# **ChiCycle Objection to Planning Application 22/01485/OUTEIA Phase-2 of the West of Chichester Development (Part 1)**

ChiCycle object on grounds that the Transport Assessment makes misleading claims about the quality of proposed transport infrastructure. It also exaggerates the scheme's potential to stimulate modal shift towards sustainable travel.

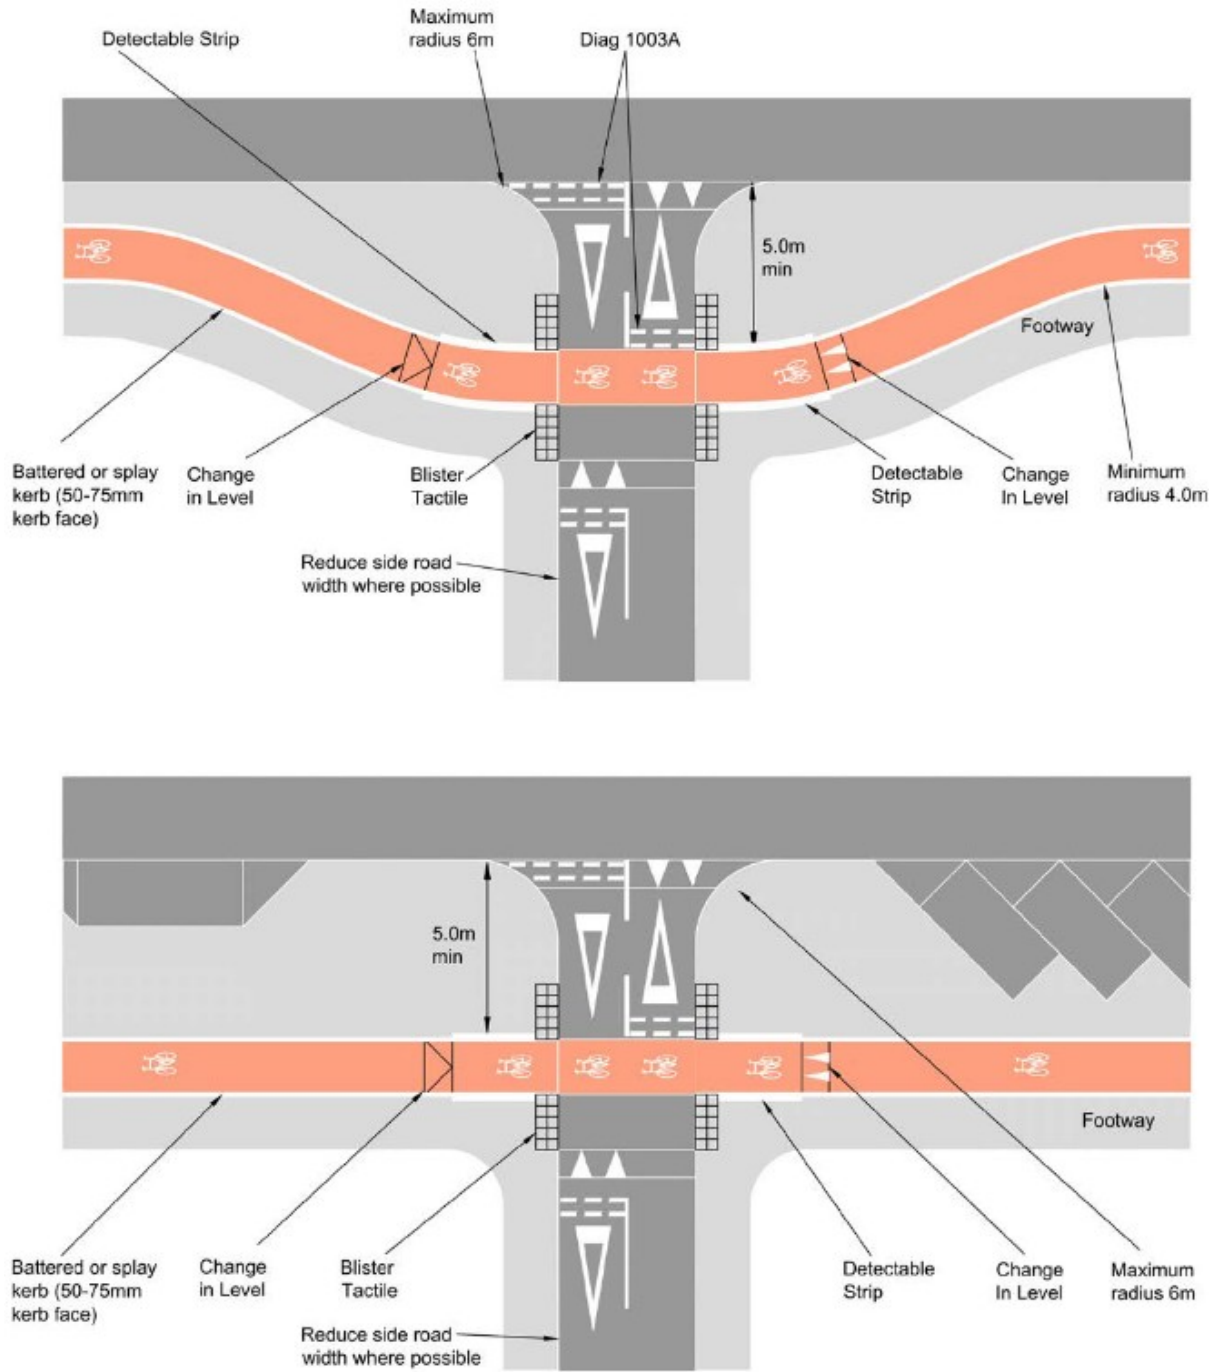
(1.3) Proposed side road crossings fail to follow appropriate standards. LTN1/20 section 10.5 covers design of priority junctions where cycle-ways cross side roads. Two way cycle-ways that maintain priority at side roads are not considered safe unless the cycle crossing is “set back” a minimum of 5 metres from the main axis kerb-line. LTN1/20 paragraph 10.5.24 states:

The proposed cycleway leaves two way cycle-traffic running flush over the mouths of side road junctions with no setback. This will cause unacceptable risks of collision between cyclists and the motor vehicles turning into the junctions. LTN1/20 Figure 10.15 shows the recommended layout for a two-way cycle track to safely cross a side road:

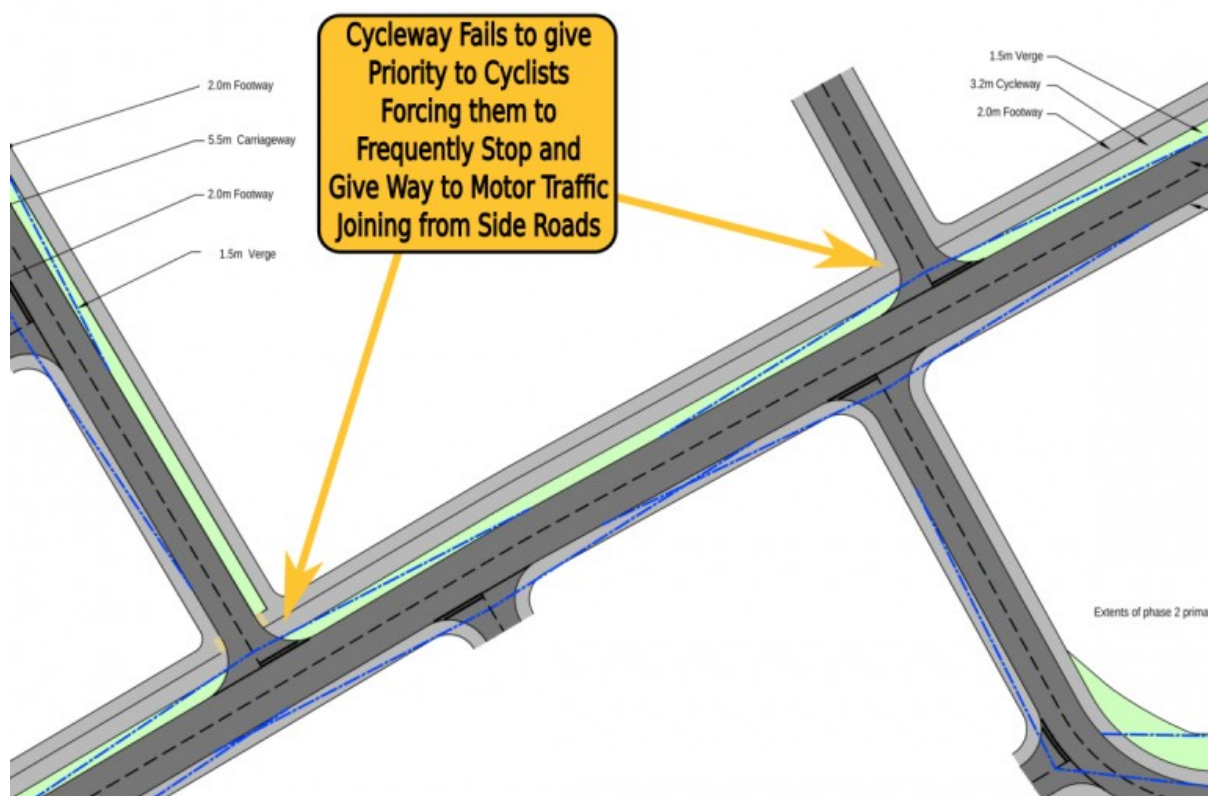
Despite guidance given from both LTN1/20 and the West Sussex cycling design guide that cycle-ways should maintain priority, the proposed spine road cycle-route will force cyclists to give way to traffic at side roads.

The following diagram highlights where planning application 22/01485/OUTEIA fails to give priority to cyclists. This will make the cycle-way of little use for commuters as cars will stop at the give way markings blocking the progress of people cycling to work or school on a bike:

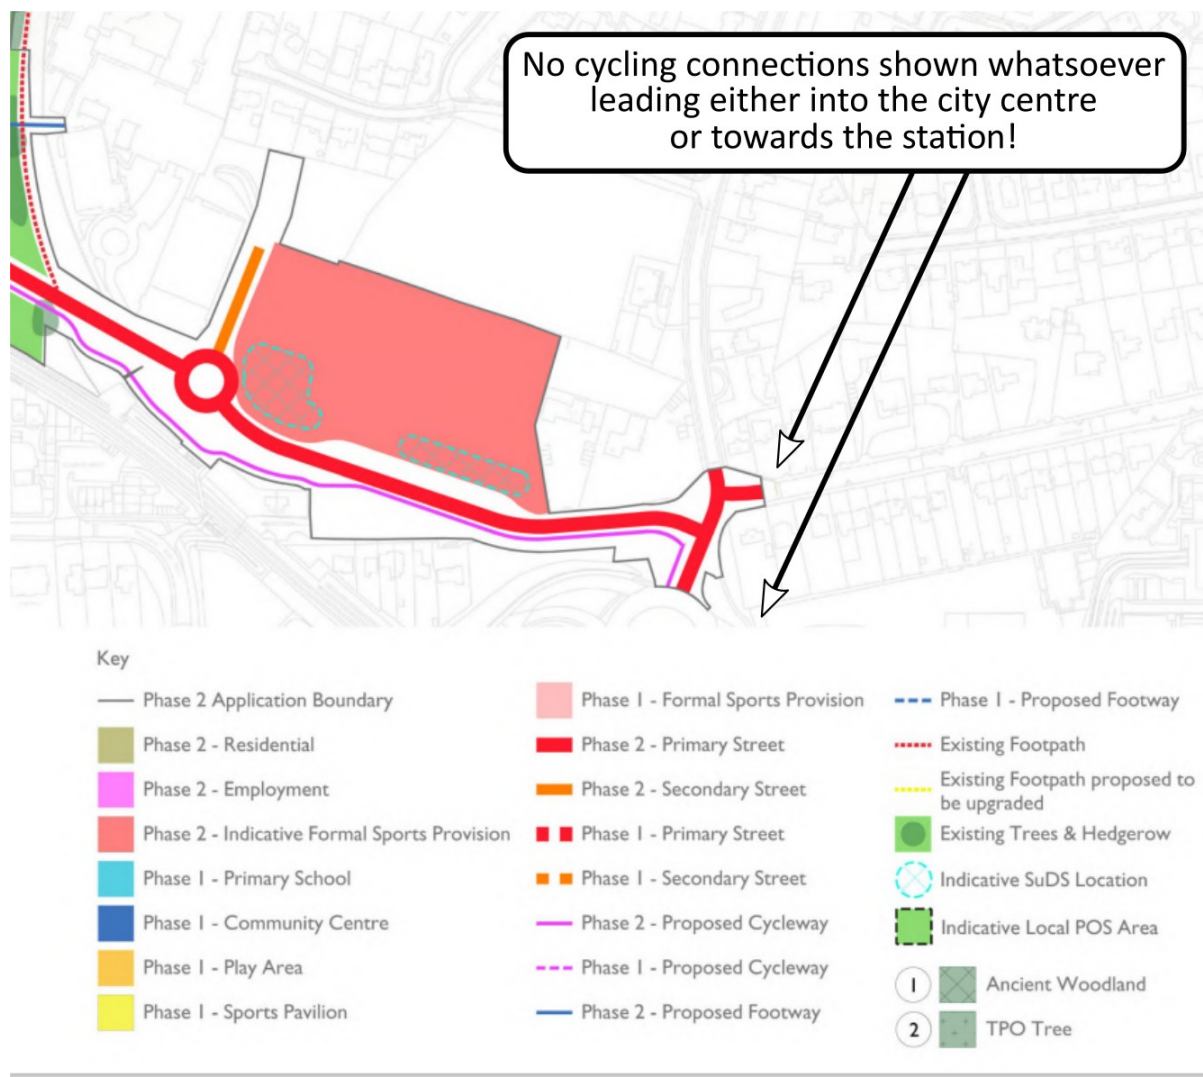
(2.5) The proposed pedestrian and cyclist's movement plan illustrated within Transport Assessment Appendix A show no cycling connections whatsoever leading either into the city centre or towards the station!

At the junction of Sherborne-Rd and Westgate, the only cycle connection shown leads into the North West quadrant of the College roundabout. This is not a suitable location for inclusive cycling because the road crossings are extremely hazardous. The following screen clip taken from the Transport Assessment Appendix A shows there are no cycle routes leading into the city centre or towards the station:

Cycle movements are shown in purple. It can be seen none of these lead into the city!
